COMMUNITY DEVELOPMENT DEPARTMENT REPORT

HEARING January 13, 2026
DATE: *Continued from: 12/9/2025*

TO: Mayor & City Council
FROM: Sonya Allen, Associate Planner
 208-884-5533
 sallen@meridiancity.org
APPLICANT: Gregg Davis, Breckon Land Design
SUBJECT: H-2025-0030
 Cherry Blossom East Subdivision
LOCATION: 523 W. Cedarburg Dr. and the 0.67-acre
 property to the east, located in the NE 1/4
 of Section 12, T.3N., R.1W. (Parcel
 #R1386850820 & #S1212120695)

D. Landscape Plan (date: 5/7/2025 8/21/2025 10/31/2025)

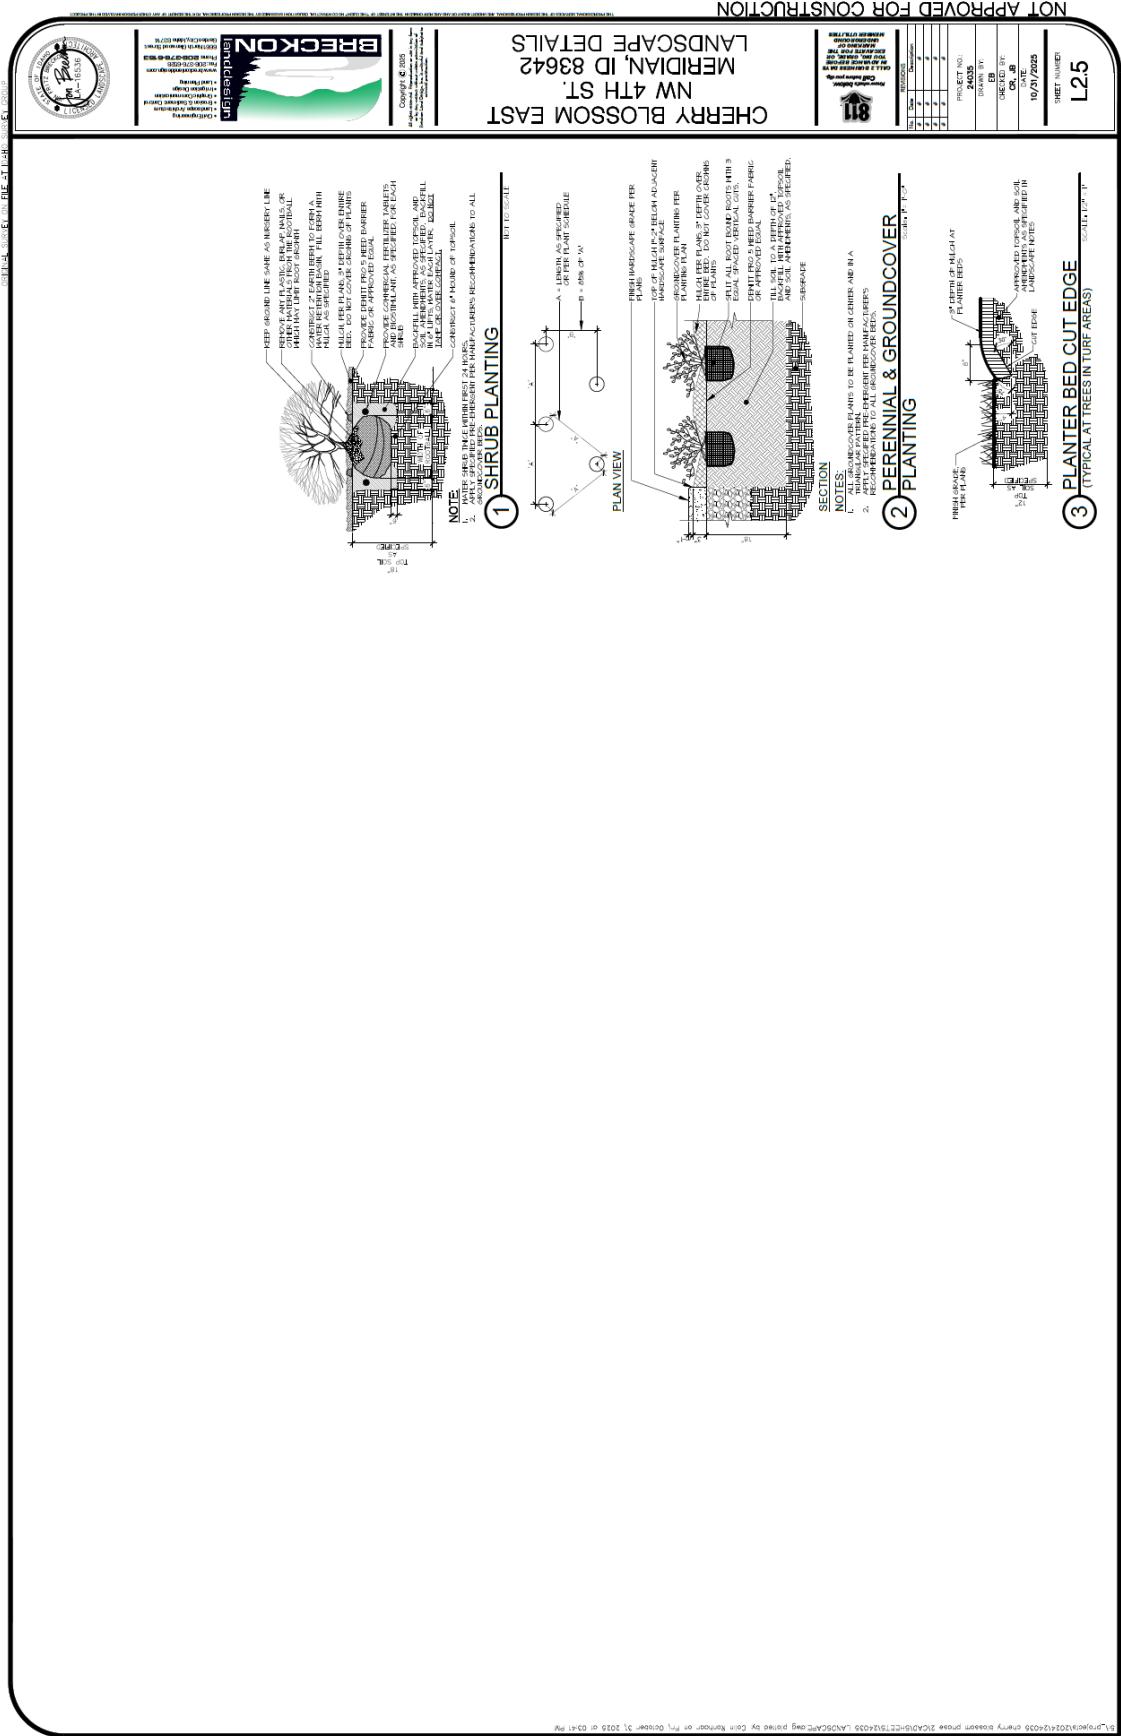
- 3. The landscape plan shall be revised as follows:
 - i. ~~Remove the fencing along the southern boundary of the property adjacent to the common driveway. The fencing has been removed.~~
 - ii. Ensure no trees are located within 10-feet of the water meter; revise plan accordingly.

E. Final Plat (date: 12/13/2025 s/b 12/13/2024 8/21/2025 11/2/2025)

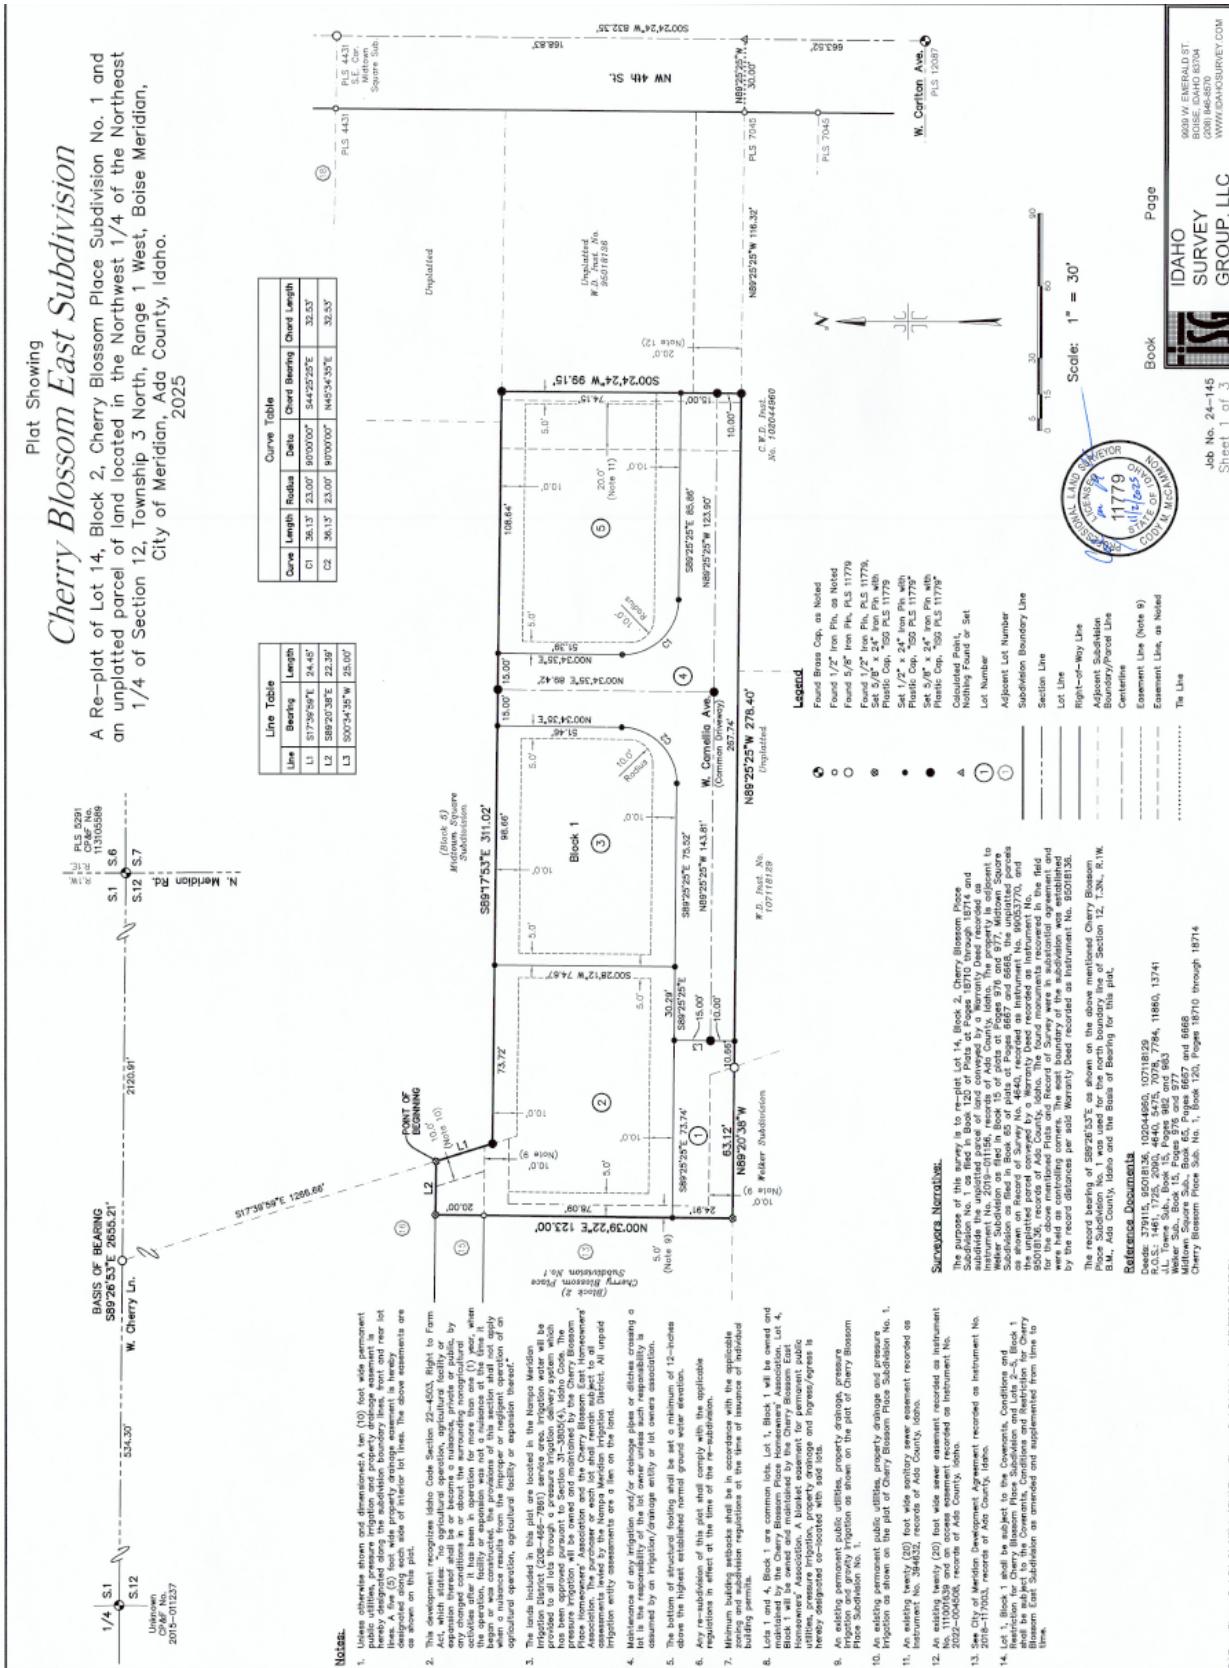
A common driveway is proposed on the subject property from the existing access easement for access to the proposed lots with a turnaround for emergency and waste disposal vehicles. The final plat depicts a street name (i.e. W. Camellia Ave.) for the common driveway, which needs to be removed as common driveways cannot be named, nor was a private street application submitted with the subject application.

2. The final plat shall be revised as follows:
 - i. Note #78: Include a note requiring maintenance of a paved surface capable of supporting fire vehicles and equipment on Lot 4 in accord with UDC 11-6C-3D.8. Also, include the ingress/egress access easement on Lot 4 is perpetual. Include that Lot 4 will be owned by the Homeowner's Association and the common driveway on Lot 4 shall be maintained by the owners of Lots 2, 3 and 5.

- iii. Remove the private street name (i.e. W. Camellia Ave.) from the plat as common driveways cannot be named.

- vi. Modify note #1 as follows: “. . . a ten (10) foot wide permanent public utilities and property drainage easement in hereby designated along all lot lines common to a private street the common driveway. . . .”

F. Common Driveway Exhibit (date: 5/7/2025 8/21/2025) - REVISED

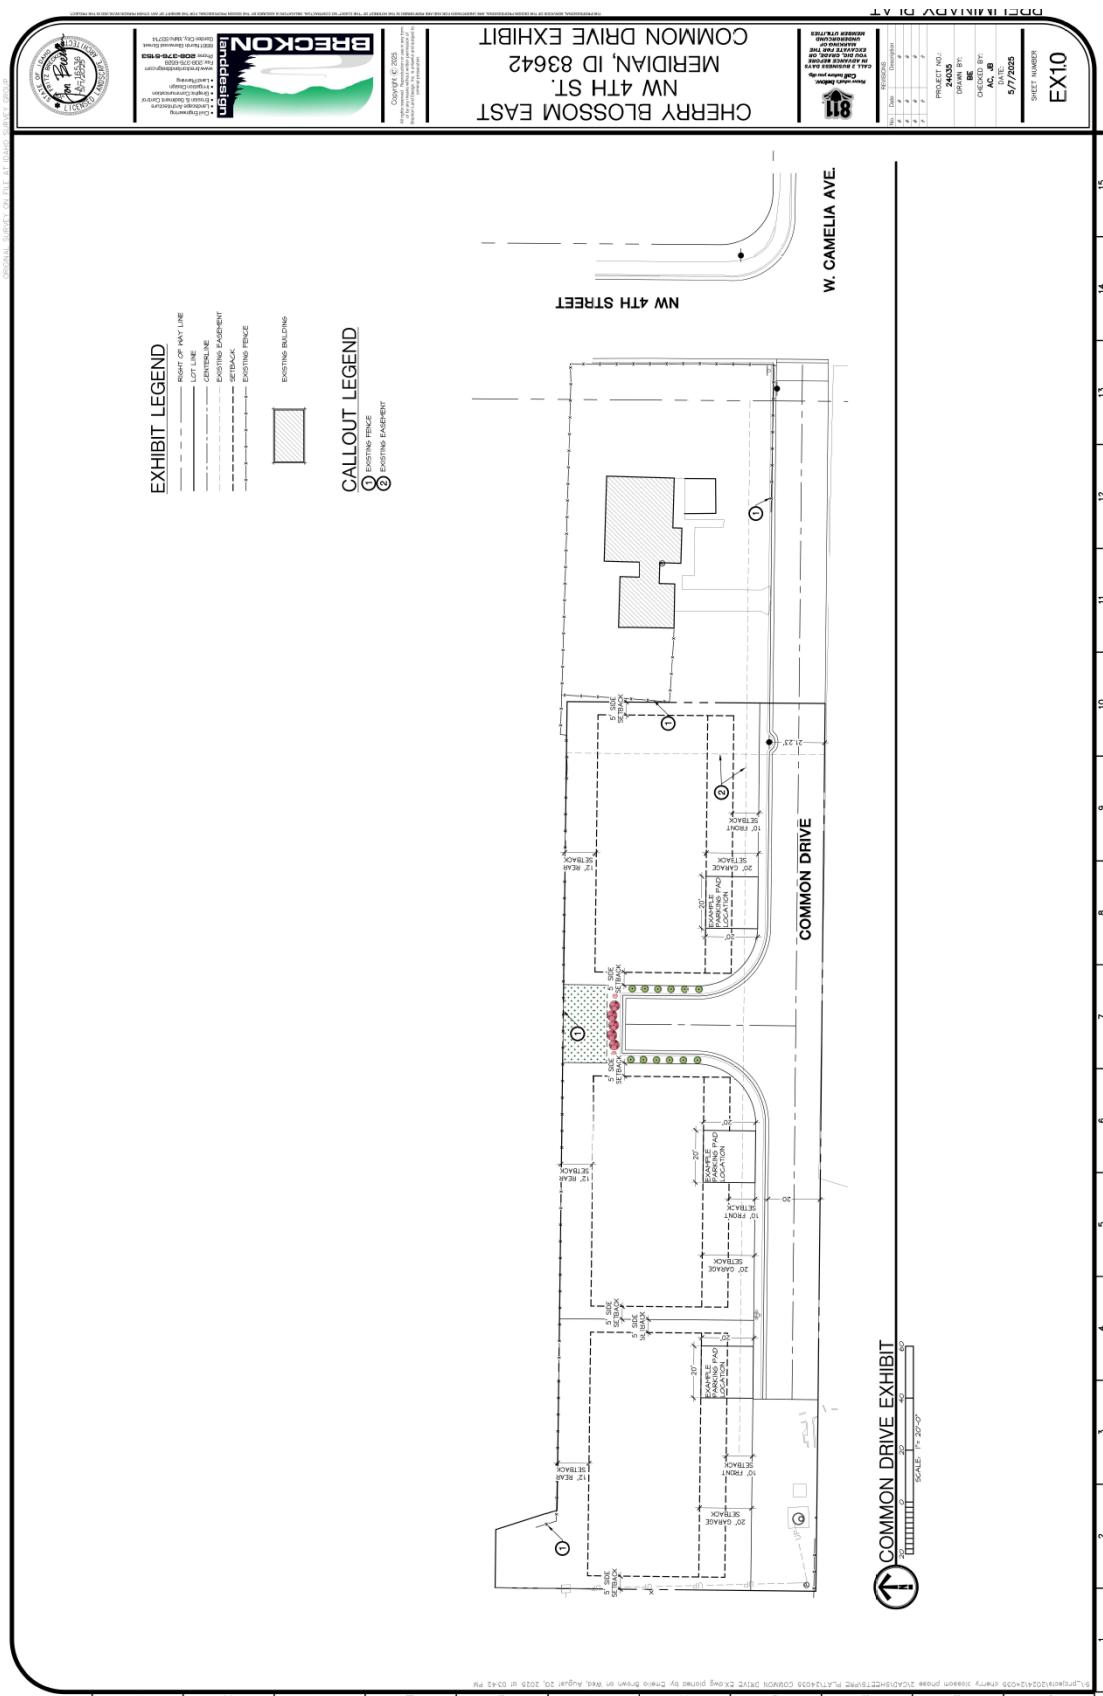
The width of the existing driveway on the Fusselman property and the proposed common driveway on the subject property is slightly constrained due to the location of a power pole and retaining wall on the Fusselman property and a power pole on the subject property, as shown on the common driveway exhibit below in Section VII.F. Because these constraints are existing conditions, the Fire Dept. and Planning Division have approved the reduced driveway width only in those areas. The width of the driveway should be 20' in all other areas in accord with UDC 11-6C-3D.

The driveway is required to be 20 feet wide – rolled curb may be provided if needed for drainage at the back edge(s) of the driveway; the common driveway exhibit should be revised accordingly prior to the City Council hearing to reflect a 20 foot wide flat driving surface or alternative compliance should be requested to UDC 11-6C-3D.2 if the width cannot be accommodated. The proposed driveway is 370 feet long, which exceeds the desired length standard of 150 feet or less. Driveway lengths exceeding this standard may be allowed if approved by the Meridian City Fire Department – Fire Dept. has granted approval of the proposed driveway length. The driveway is required to be paved with a surface capable of supporting fire vehicles and equipment – plat note #78 should be amended to require maintenance of such for that purpose; the ingress/egress easement is also required to be perpetual and should be included in plat note #78 as such. The developer has stated maintenance of the common driveway will be the responsibility of the three (3) lots that take access from the driveway.
